This page lists the known errors on the gm5x5x5 PCBs. There are no known issues with the bulk order run (white pcbs), the following information is valid **only** for the prototype run (green pcbs).

Prototype Run

#1 MIDI IO pins

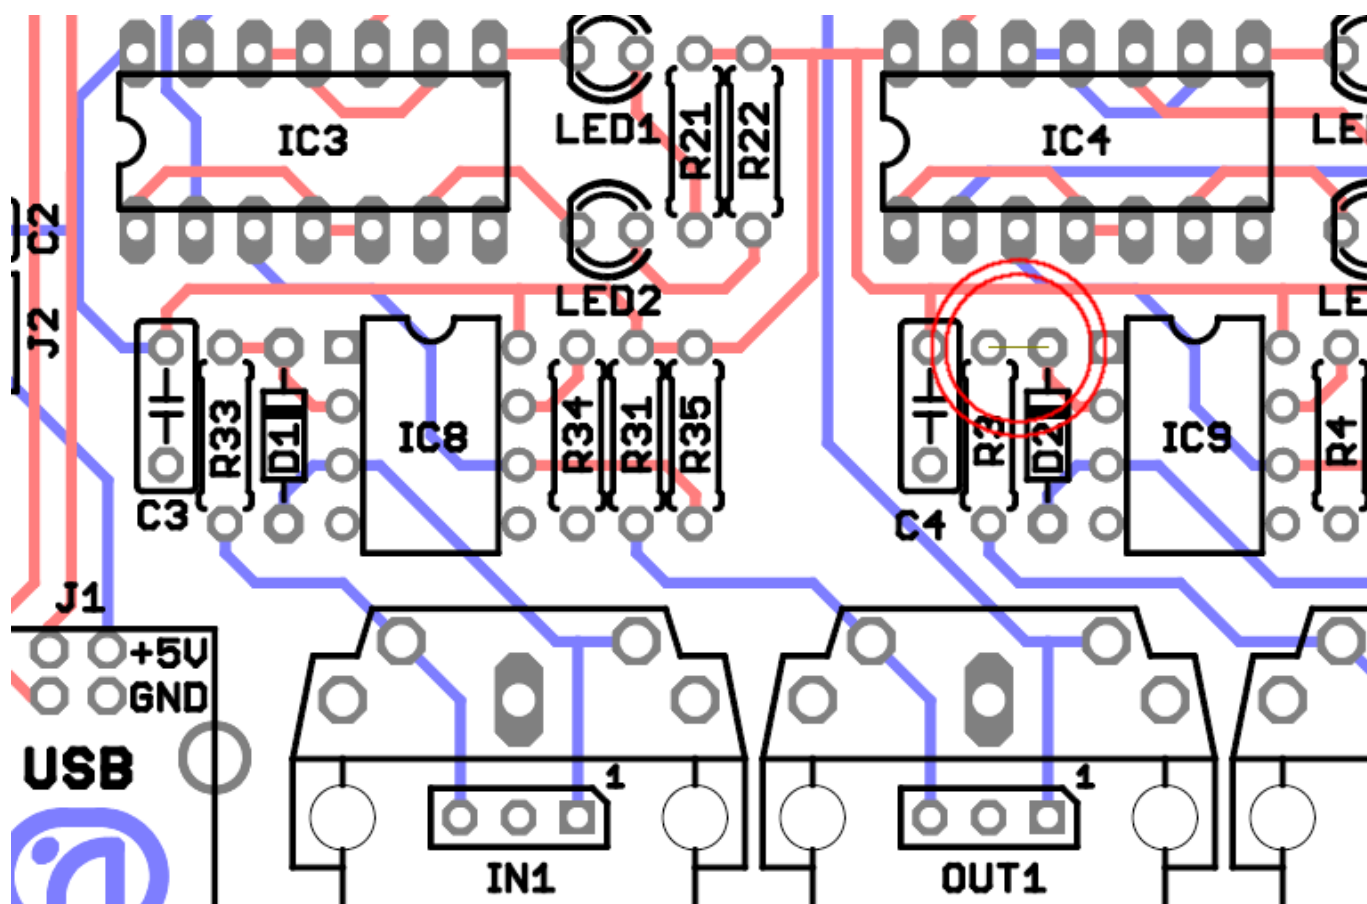
Problem: The MIDI IO pins of the midi sockets (Pin 4 + 5) are switched.

Solution: Either (1) use the pin-headers if you use sockets that are not mounted on the pcb or (2) break the traces to pins 4 + 5 of the sockets and solder wires to them or (3) solder the midi sockets on the other side of the pcb.

Problem: A track between D2 and R3 is missing.

Solution: Bridge the pins.
